Proposed Decision to be made by the Portfolio Holder for Transport and Planning on or after 7 December 2018

HS2 Phase 2b Working Draft Environmental Statement (WDES) Consultation; Warwickshire County Council's Response

2.10 Austrey Playing Fields

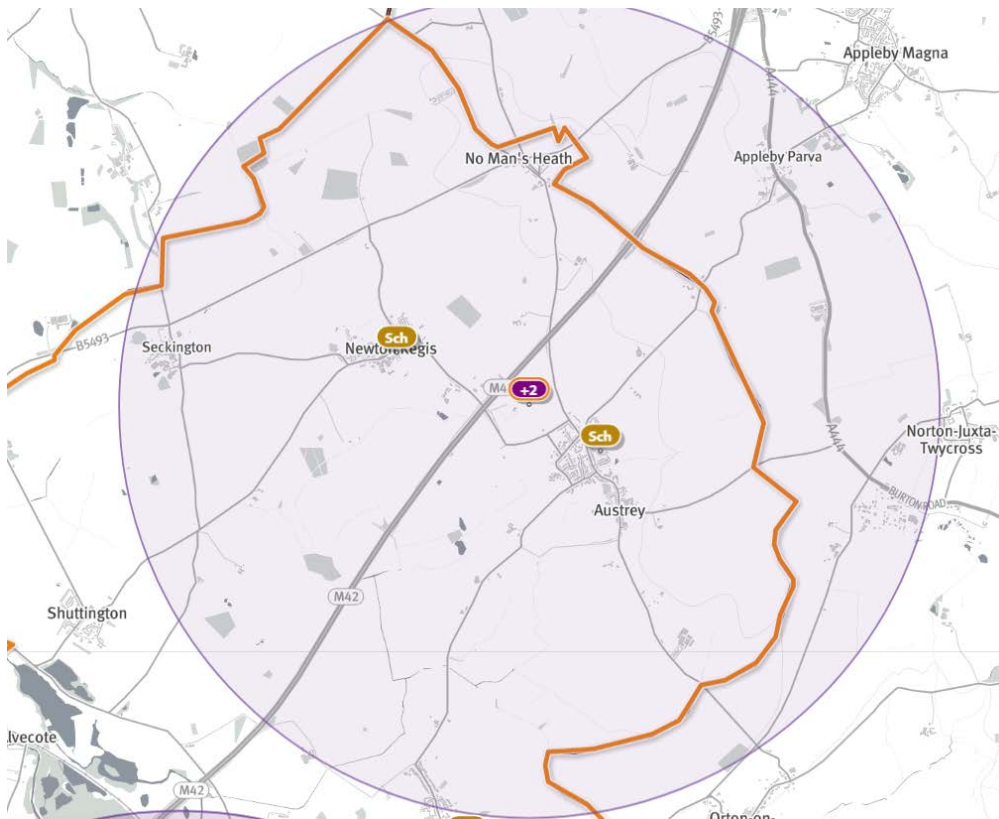
2.10.1 The council understands there is a level of community anxiety over the current playing field proposal. This is a vital community asset and is central to the social fabric of the village. The WDES acknowledges that: 'The affected playing fields would no longer be usable given that the loss of land would impair the ability of users to utilise the resource for its intended purpose.' and 'there is no adequate alternative resource in the local area'. (see reference to Volume 2:LAO2 page 88, para 6.4.19.)

2.10.2 The facility provides an essential public green space for all age groups to enjoy. The loss of the play area, sports pitches and land utilised for community activities would have a materially detrimental effect on village life.

2.10.3 The land loss is exacerbated by the access issues caused by the permanent diversion of Newton Lane which frustrates access to the playing fields from neighbouring communities. Also, the usage of Newton Lane as a HGV route poses an additional conflict between construction traffic and villagers travelling to the site from the centre of the village on foot or bicycle.

2.10.4 Dialogue between HS2 Ltd and the community has not yet yielded any assurances despite the parish council being proactive in identifying an alternative and available site within the centre of the village which they consider suitable. It is the council's view that an early resolution on this matter must be reached to enable the village to minimise the impact on the community, remove the need to comment or petition and potentially allow HS2 to take possession of the old site in preference to other productive agricultural land for construction. The provision of the replacement facilities will require both the support of the LPA (Local Planning Authority) and a detailed assessment of any potential impacts on the historic environment (including archaeological features).
